Project No. 2023_079

MIDLOTHIAN ISD FRANK SEALE MIDDLE SCHOOL
INDOOR GOLF FACILITY

December 20, 2023

2 TECHNOLOGY FLOOR PLAN
Scale: 1/4" = 1'-0"

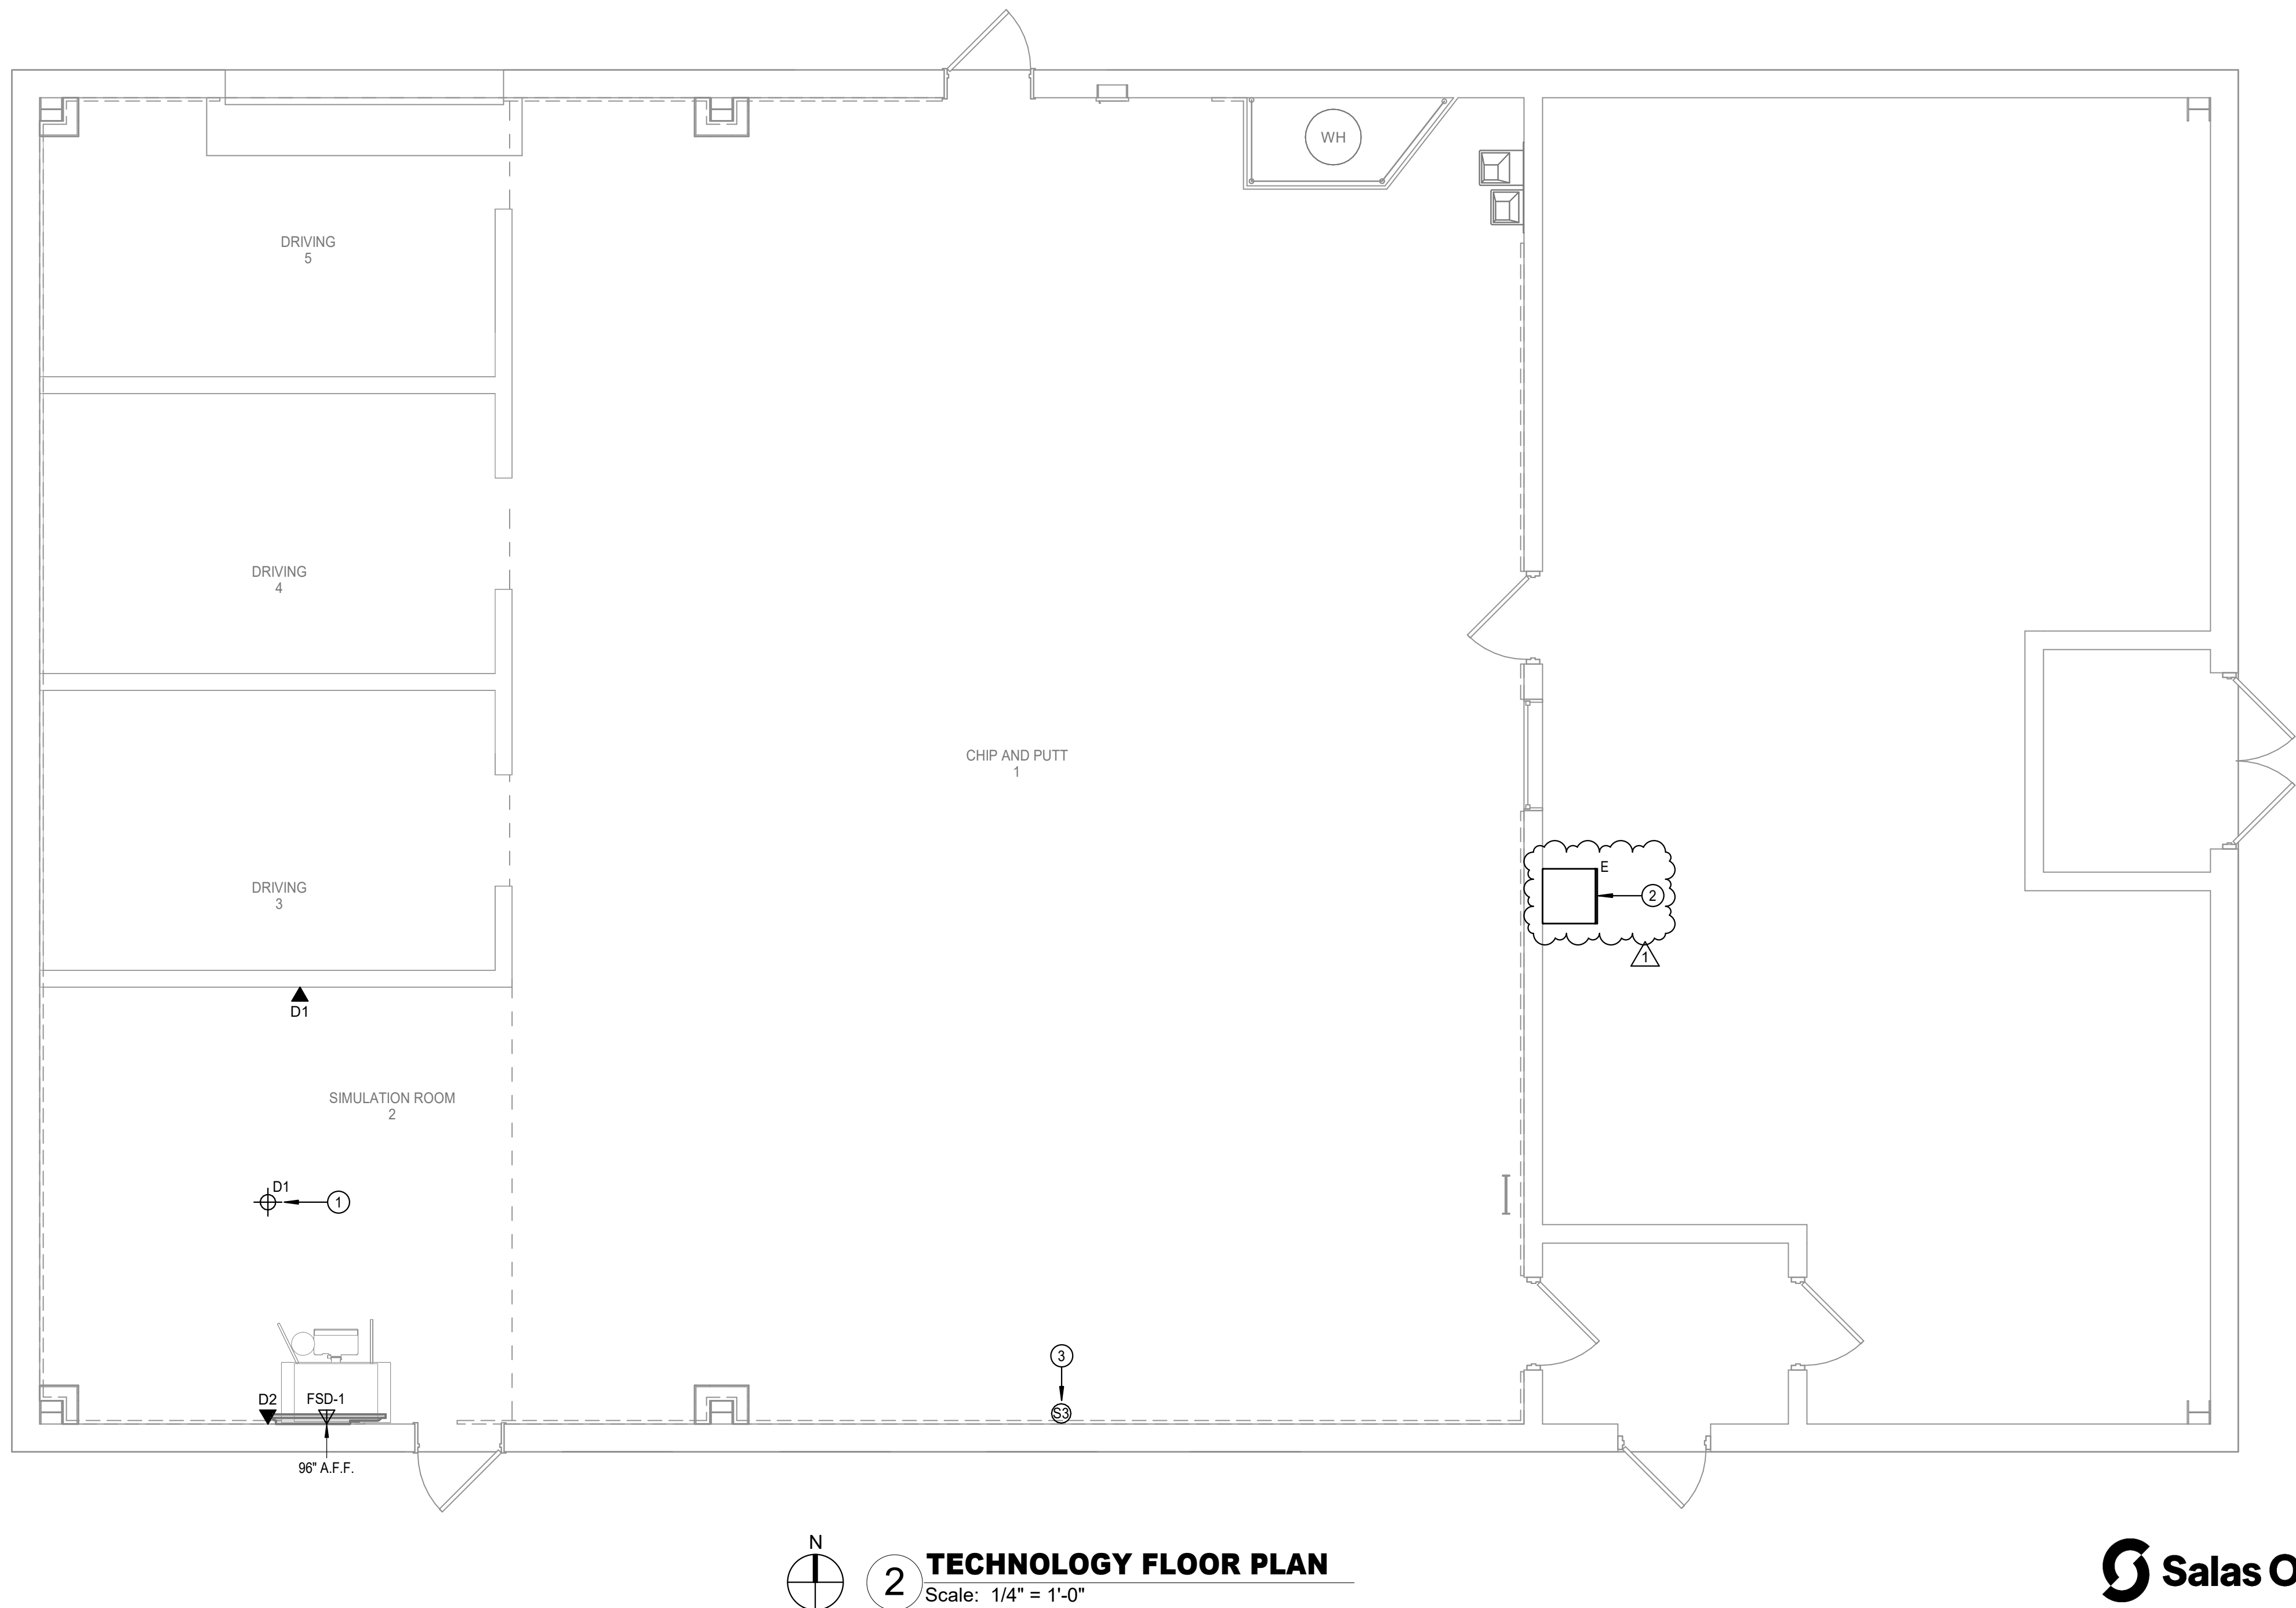
7. Note 3 on T-200 shows to update an existing P/A speaker to match the existing school. There are no specifications or details on what type of speaker this is. Please advise.

1. Seals added.
2. Added Intercom legend.
3. Revised responsibility matrix.
4. Revised technology keyed notes #3.
5. Added existing wall mounted cabinet approximate location.

A specification for the P/A speaker has been provided on sheet T-201 Technology Sheet Specifications.
